# UNITED STATES PATENT AND TRADEMARK OFFICE

APPLICATION NO.	FILING DATE	FIRST NAMED INVENTOR	ATTORNEY DOCKET NO.	CONFIRMATION NO.
10/500,623	07/02/2004	Andrew MG Westcott	540-508	2994
23117	7590	10/18/2006		
NIXON & VANDERHYE, PC 901 NORTH GLEBE ROAD, 11TH FLOOR ARLINGTON, VA 22203			EXAMINER AMAYA, CARLOS DAVID	
			ART UNIT 2836	PAPER NUMBER

## Office Action Summary

## **DETAILED ACTION**

Fig.1.  
 (Prior Art)

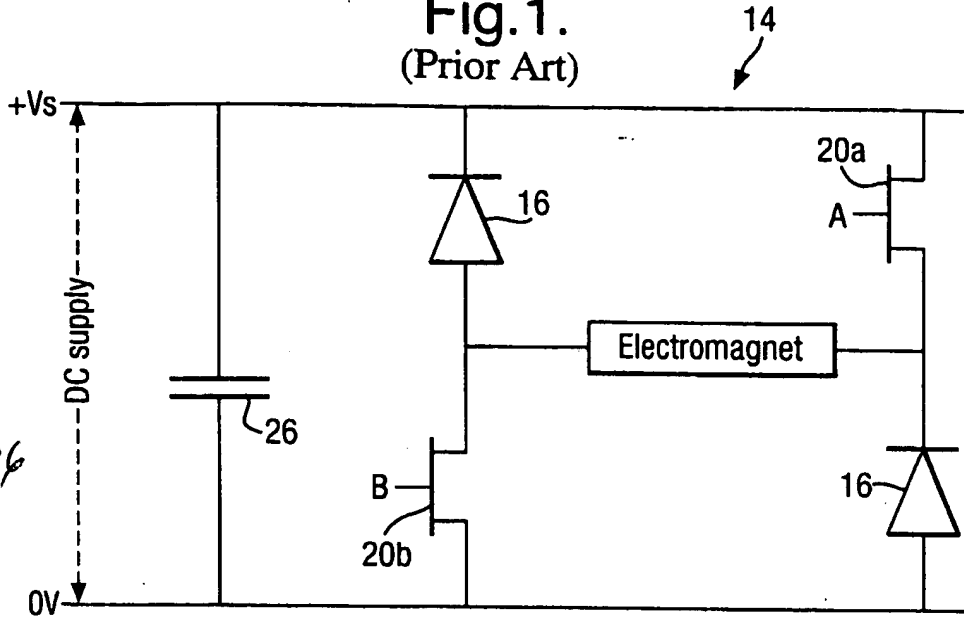
Approved  
 C.A. 10/06/2006
